John Deere S7 & X9 Stripper Header Compatibility

Issue	Date	Changes
1	16/04/2025	Technical parts bulletin created

John Deere S7 & X9 Multi-Function Lever Mounted Switch, Shelbourne Reynolds Part No. **KIT-01492**

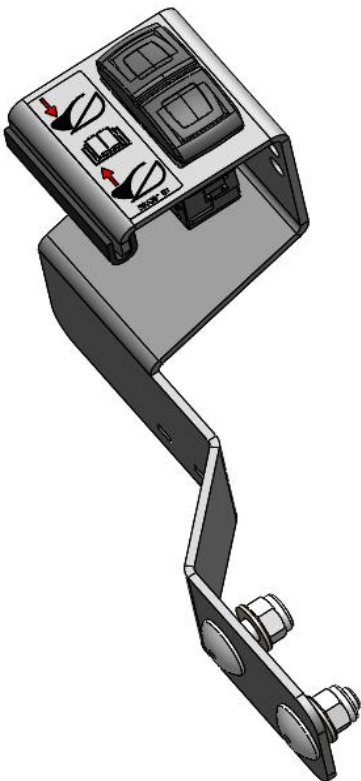
A combine multi-function lever mounted switch will be available (June 2025) as an alternative to the console bracket-mounted rocker switch. This molded switch assembly fixes to the John Deere multi-function lever.
